**Re: NMCC Expansion  
4901 Lang Ave. NE  
Conceptual Traffic Circulation Layout for DRB Approval  
Engineer's Stamp 08-24-22 (D17-D003V1)**

**Reference: NMCC Expansion – 4901 Lang Ave. NE Traffic Circulation Layout (DIV-D003V1)  
Comment Response Letter, 4th Submittal**

TRAFFIC CIRCULATION LAYOUT  
NMCC EXPANSION  
4901 LANG AVE. NE

C-102

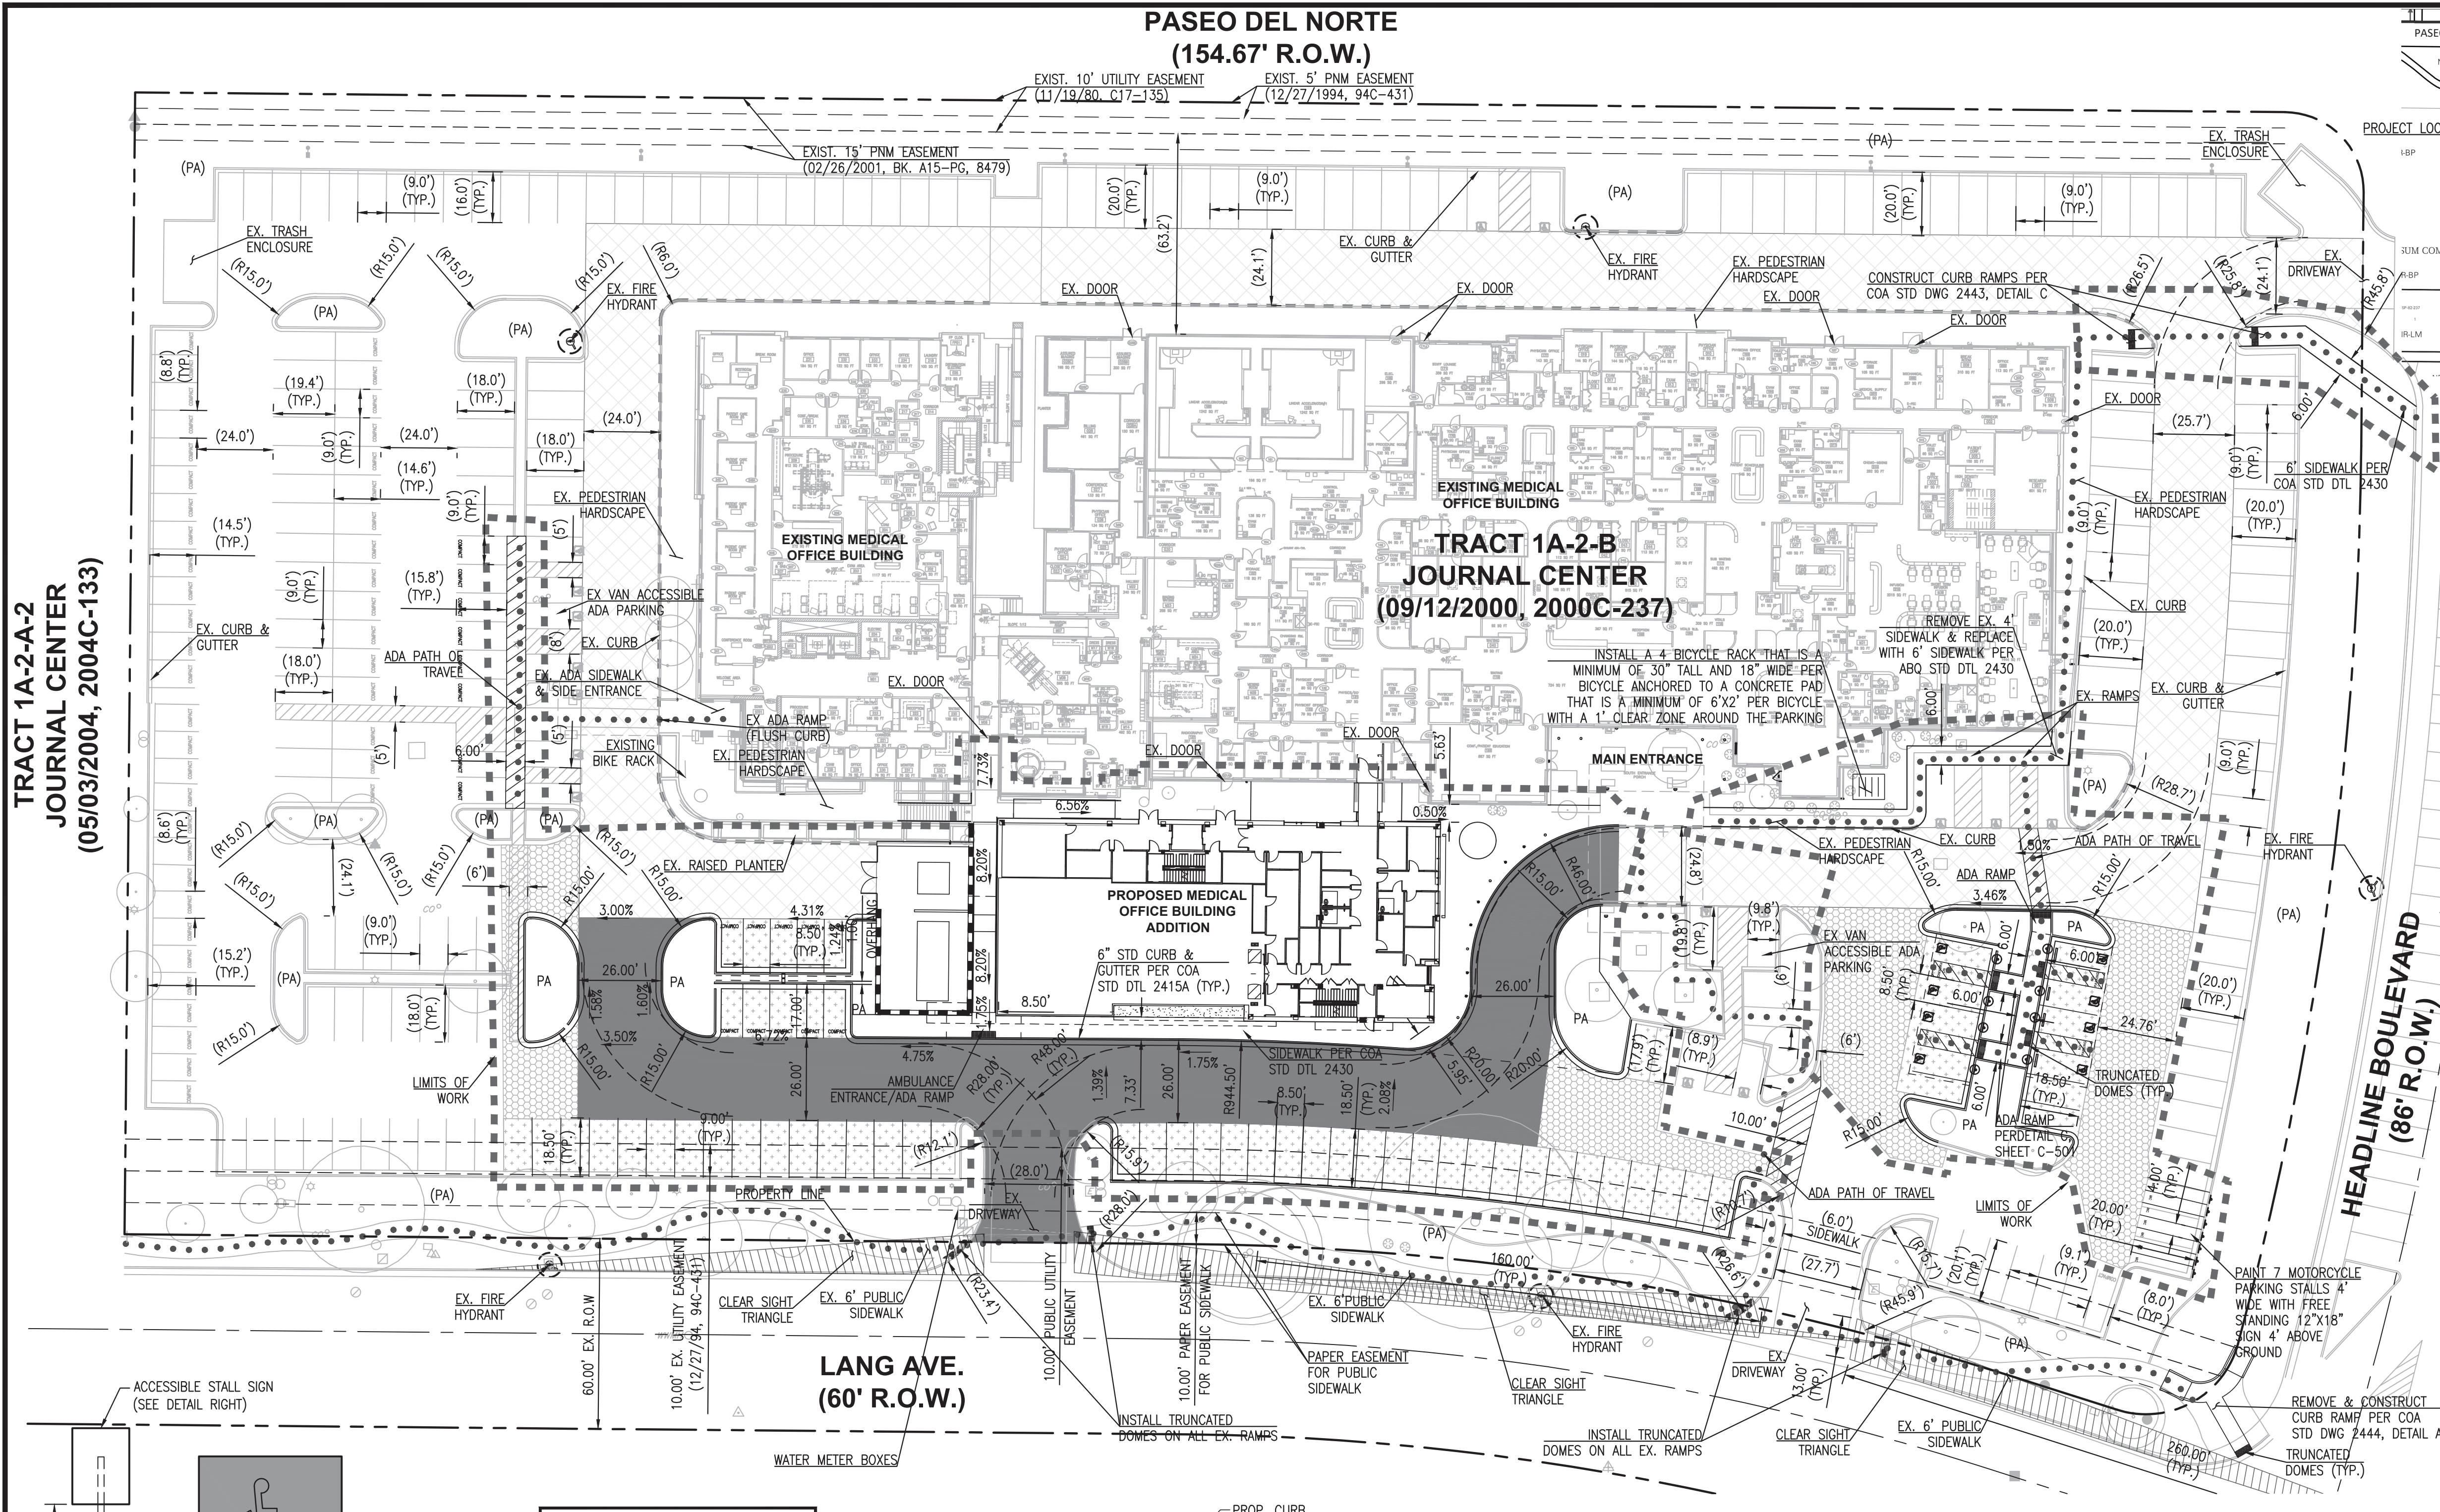
6. The pavement marking “MC” should be shown opposite direction for motorcycles entering the parking space.

7. Please provide details for all the proposed signage and pavement marking.

*Response: “MC” is now shown on the pavement of each motorcycle stall.*

*Response: Details A was revised to include motorcycle parking striping, Details B & C show Van accessible signage and striping information. All other signage and striping was already accounted for in the plans.*
